MEMORANDUM

File No.: DRV12-00921

Subject: **LAKE STREET PLACE - CONCEPTUAL DESIGN CONFERENCE &
DESIGN RESPONSE CONFERENCE
112 & 150 LAKE STREET SOUTH**

Sheet No. **1.1**
 Project No. 1105
 Date: 07/30/12

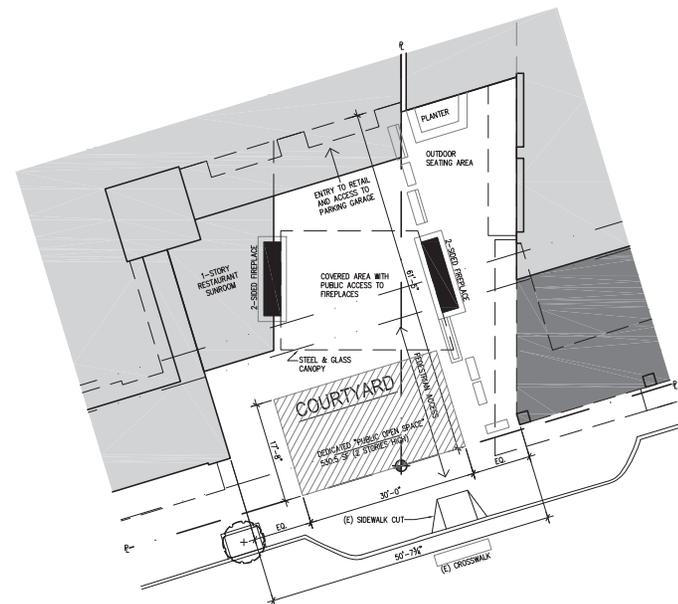
As requested by the DRB, the applicant has pursued Alternative B (central courtyard concept) and has provided detailed plans for review (see Attachment 2, Sheet 1.1). The entire courtyard is approximately 6,900 square feet in size and located in a central area. Portions of the courtyard immediately next to restaurant tenant spaces are planned to be

utilized as outdoor dining areas. The applicant is also setting aside approximately 530 square feet of the courtyard adjacent to the Lake Street sidewalk to be preserved as 'public open space'. This is provided to offset encroaching into the required 30' upper story setback along Lake Street as allowed by code (see Section VI.C below).

Lake Street - Portions of the 3rd and 4th story with the Hector's expansion and the KWM expansion are proposed to extend up to 5' into the required upper story 30' setback from Lake Street. The applicant is therefore requesting DRB approval to encroach into the setback pursuant to KZC Section 50.10.5.f in exchange for dedicating public open space at the street level. The applicant is proposing 1,061 square feet of building area (includes balconies) within the 30' upper story setback. Based on this amount of area, the applicant is required to dedicate 530.5 square feet at the street level. The applicant is proposing to dedicate the required open space in the central courtyard along Lake Street (see Attachment 2, Sheet 1.1).

1ST FLOOR
 PLAN
 Sheet No. **2.0**
 Project No. 1105
 Date: 07/30/12

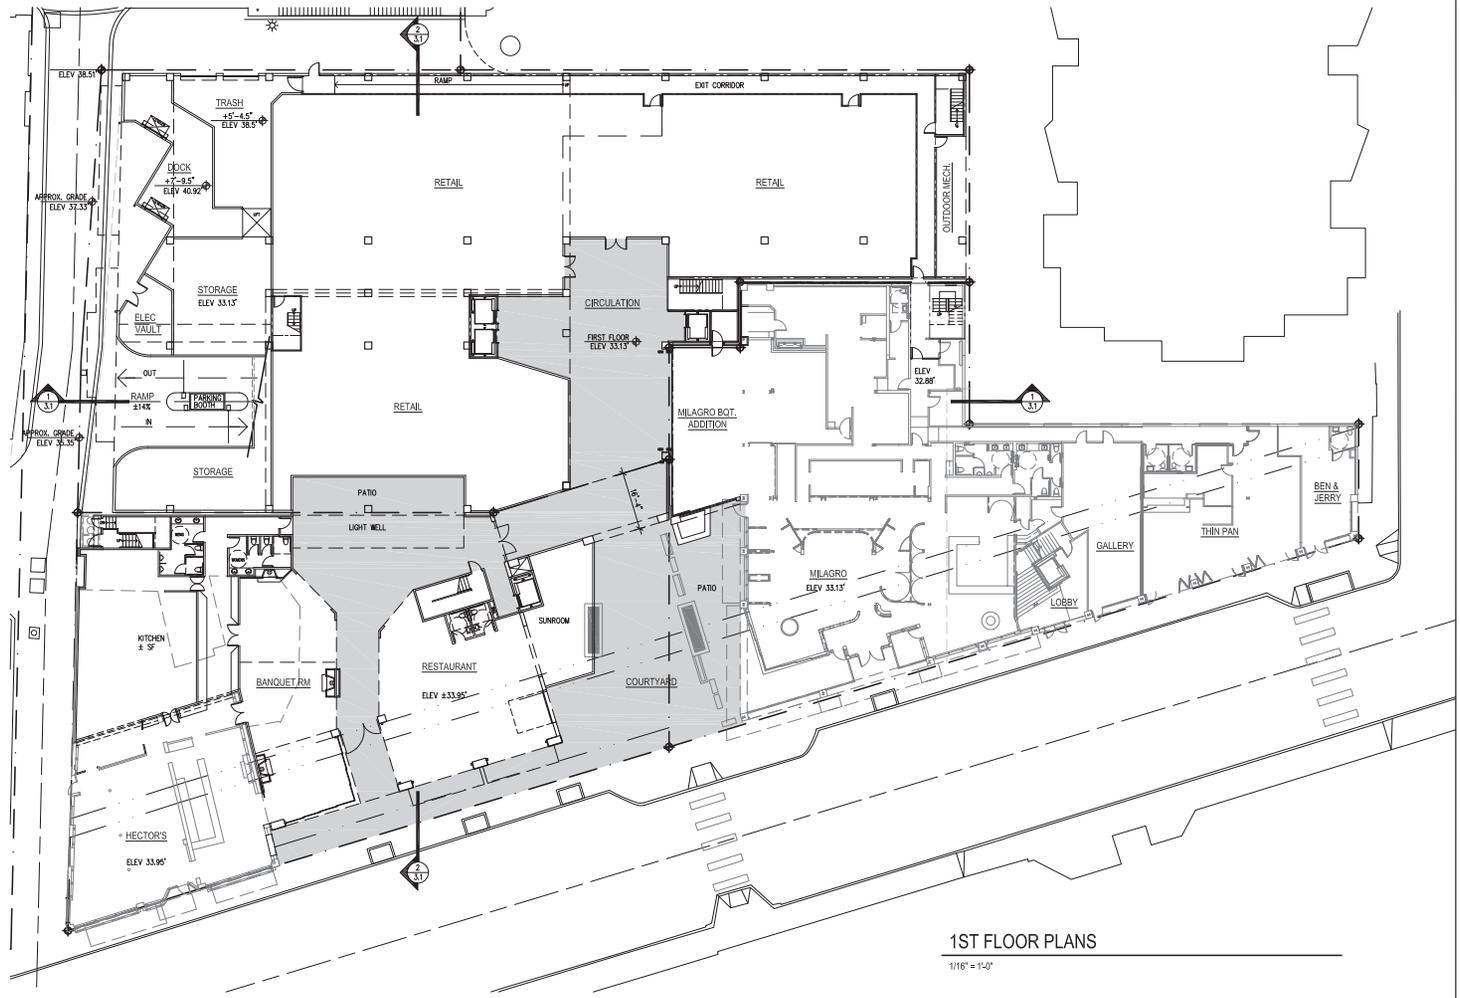
The applicant has also provided detailed information regarding the multi-story parking garage and 'back of house' functions of the project which includes the loading and trash areas (see Attachment 2, Sheets 2.0, 3.0, 4.2, & 4.3). The garage and 'back of house' areas are associated with the Main Street building located on the easternmost parcel. The parking garage is enclosed with some ventilation openings. The roof deck also contains parking.

The applicant has submitted a detailed floor plan of the garage, trash, and loading/unloading area for review. The applicant is currently working with the City Public Works Department and Transportation Engineer to address the issue of safe vehicular circulation and final configuration of the trash and loading/unloading area.

6TH FLOOR
 PLAN
 Sheet No. **2.5**
 Project No. 1105
 Date: 07/30/12

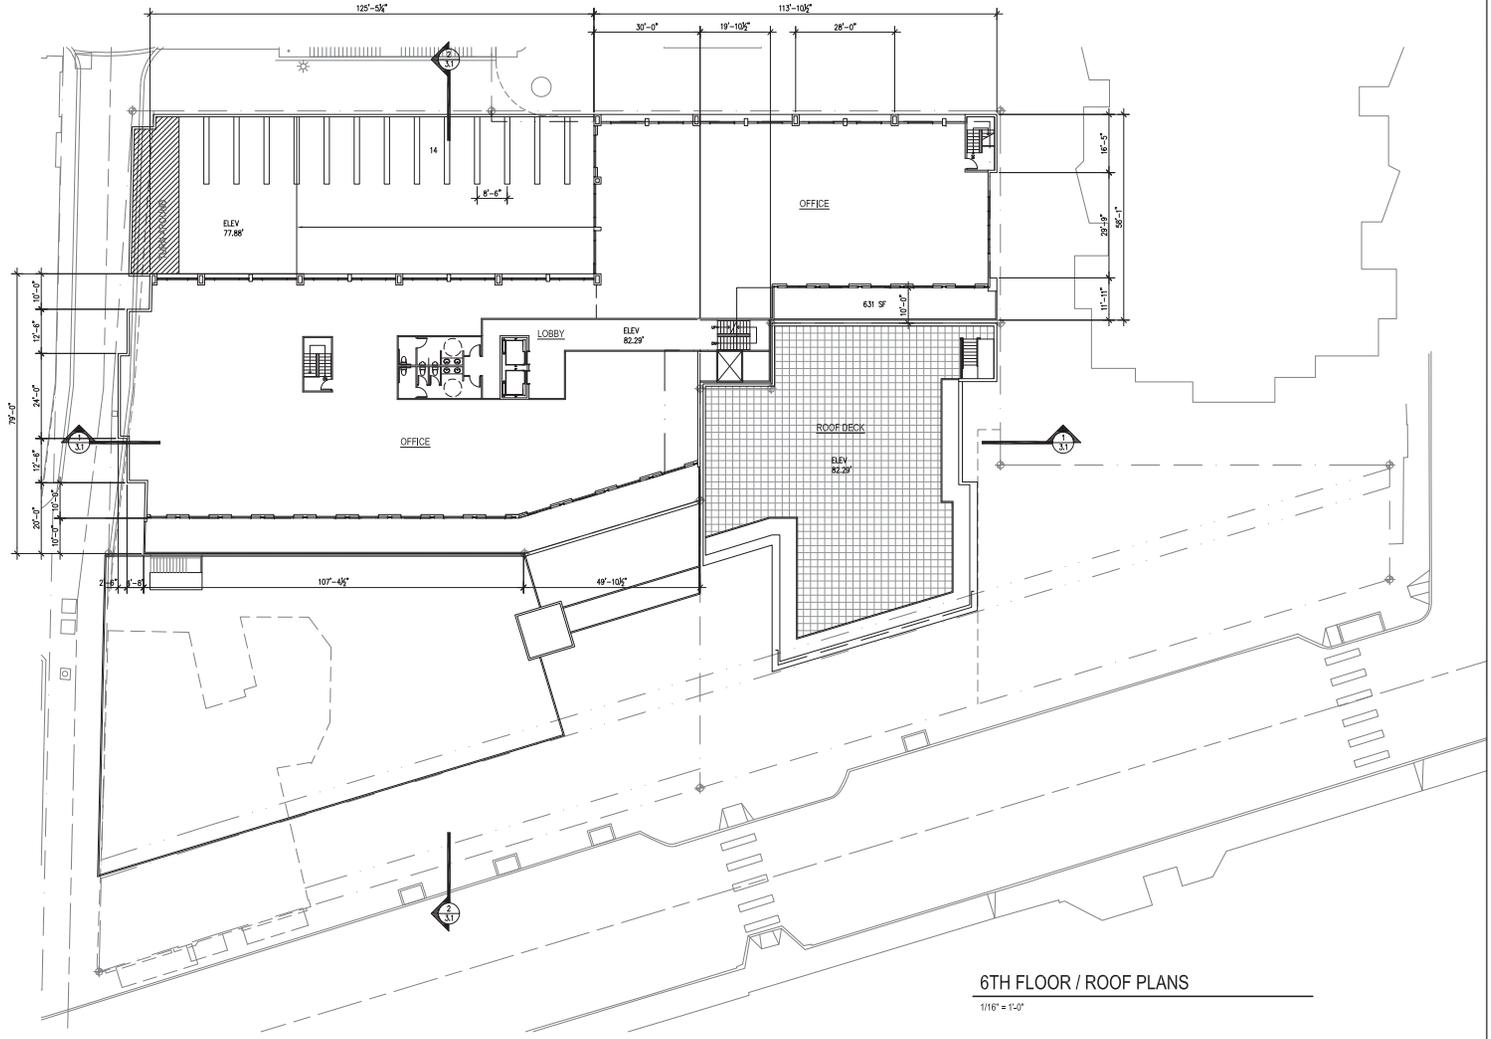
The applicant is proposing to remove floors 5 and 6 within 40 feet of the Main Street property line (see Attachment 2, Sheet 2.5). Floors 5 and 6 are actually setback 46' from Main Street.

SECTIONS
 Sheet No. 3.1
 Project No. 1105
 Date: 07/30/12

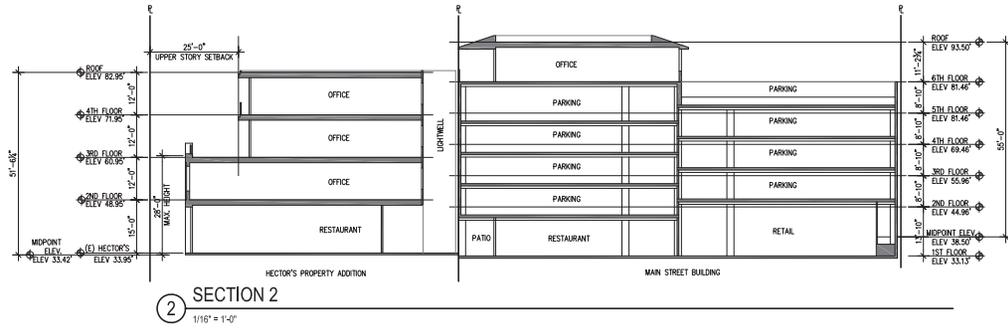
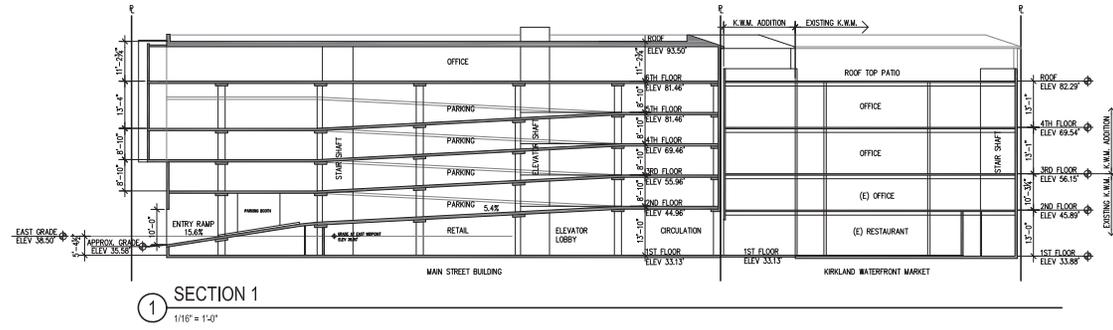
Attachment 2, Sheet 3.1, Section 2 should be revised to reflect the 46' setback from the east property line (as drawn, it reflects an incorrect 62' setback). The 46' setback at the 5th and 6th floor equates to 8,118.4 square feet of building area that is removed and is twice as much than required by code.

Sheet No. 4.5
Project No. 1105
Date: 07/30/12

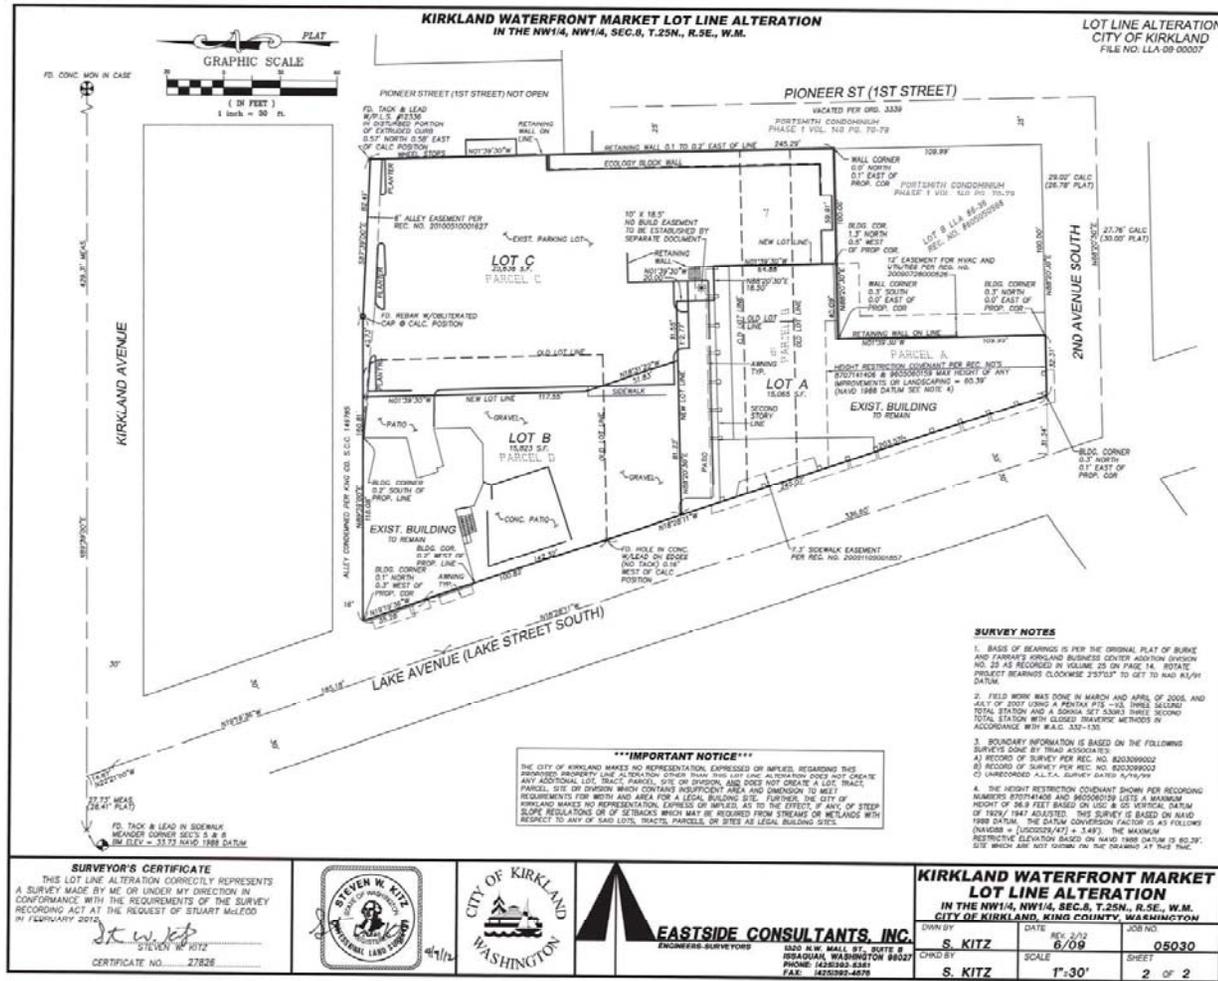
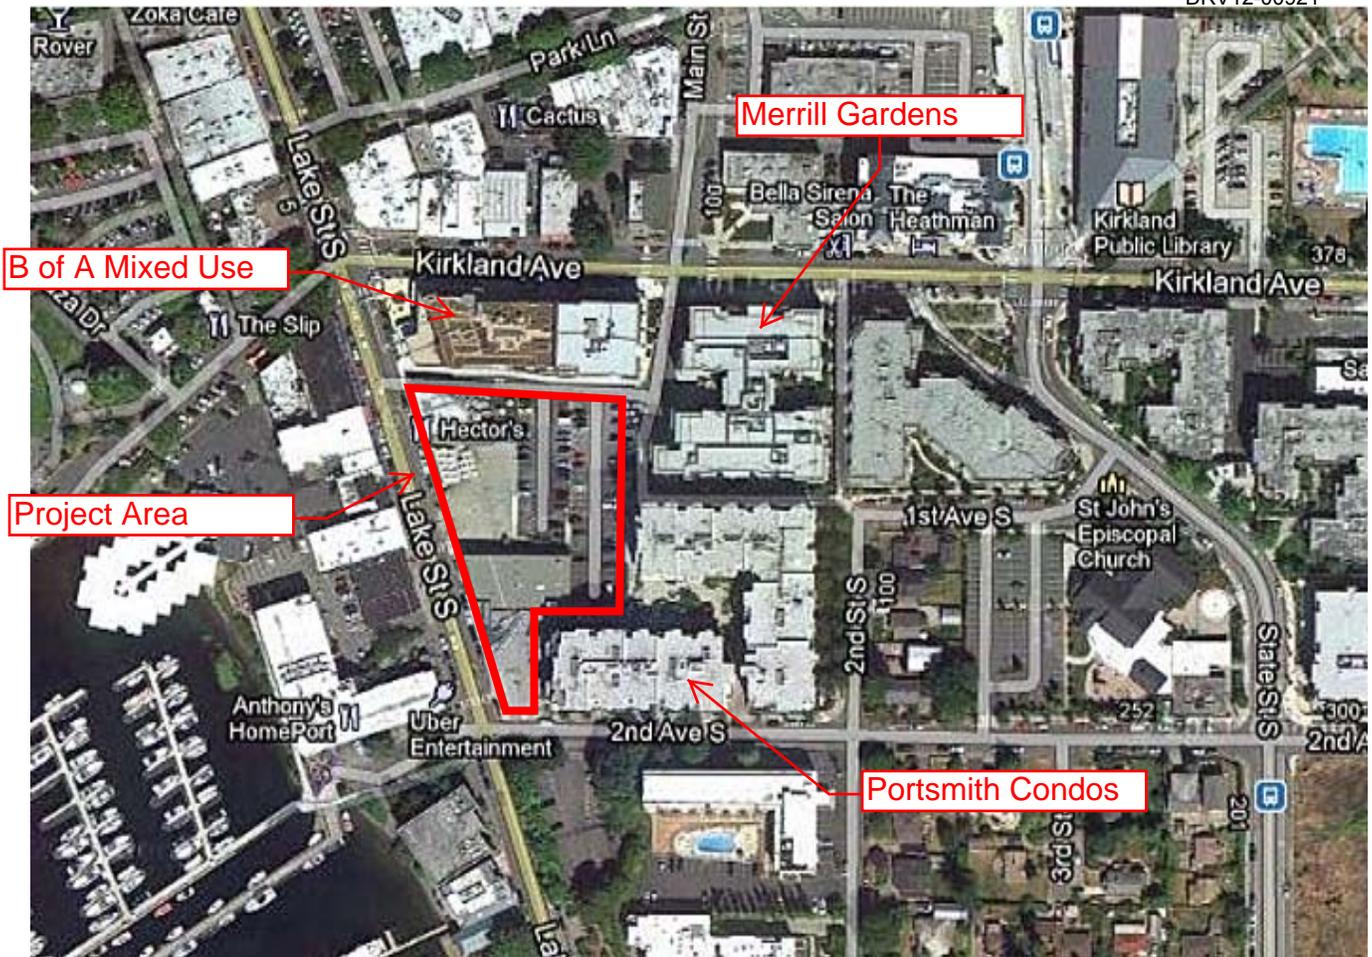
In regards to pedestrian access, a central courtyard along with a covered pedestrian walkway to the various tenant spaces internal to the property is proposed. A light well is included in the building design to provide solar access to a portion of the covered pedestrian areas. Several renderings have been provided to provide the DRB a sense of the applicant's concept of the pedestrian areas (see Attachment 2, Sheet 4.5).

- Does the DRB need additional information regarding the visibility of the trash and loading/unloading area? Is additional mitigation of these areas needed?*
- The DRB should provide feedback on the proposed pedestrian plaza and circulation system.*
